SERVICE BULLETIN 149 — MANDATORY

SUBJECT: Main landing gear trunnion tubes, possible cracking

APPLICABILITY: Glasair III main landing gear S/N 0-51

Figure 1: Main Gear Trunnion Assembly

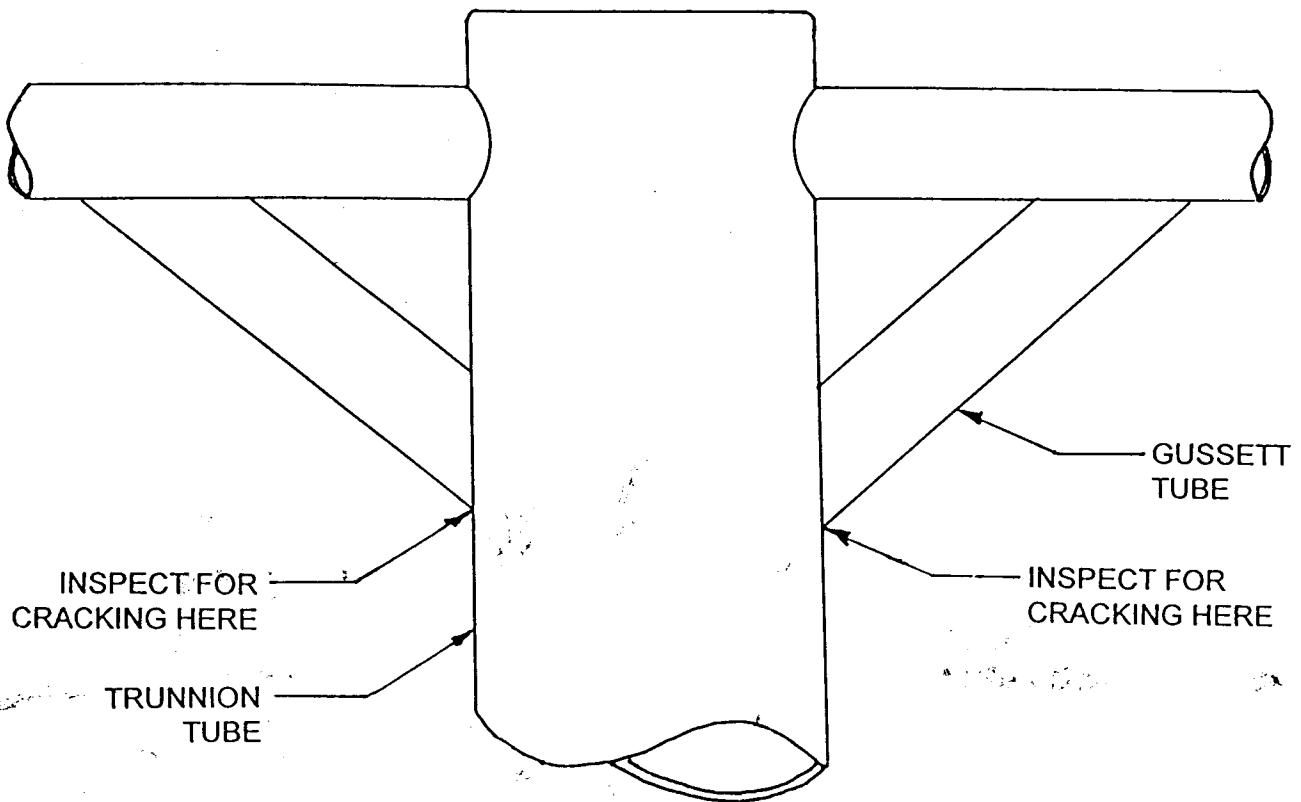
DISCUSSION: We have received reports of cracking in the main landing gear trunnion tube near or along the bottom edge of the welds where the gusset tubes join the main tube, as indicated by the flags in Figure 1. If allowed to advance, such cracking can eventually rupture the wall of the trunnion tube, causing a loss of strut pressure. If a pilot failed to note the loss of strut pressure during the preflight inspection, the strut could fail to extend on takeoff, and subsequently fail to retract into the wing properly.

REQUIRED ACTION: Before further flight, perform a visual inspection of the welds in the areas indicated in Figure 1. Check for any sign of cracking in the paint or of hydraulic fluid leakage. Repeat this inspection at intervals of not more than 25 hours of service for the life of the landing gear.

If cracking is detected, the most practical solution is to replace the trunnion assembly. The difference between the cost of a new trunnion assembly and the cost of reworking an original one is small. Our vendor advises us that the rework would take several months to accomplish, as it would require disassembly of the gear leg, stripping the paint off the trunnion assembly, re-welding the cracks, normalizing and re-heat treating the assembly, re-applying paint and reassembling the gear. Additionally, the finished product would still be an original-design trunnion, subject to cracking in time just as it did initially. The current trunnion design, on the other hand, has been upgraded in many important respects, including the use of thicker-walled tubing and the addition of gusset plates, both of which make cracking in this area extremely unlikely. For all these reasons, Stoddard-Hamilton will not support the reworking of first-run trunnion assemblies in the event cracking is discovered.
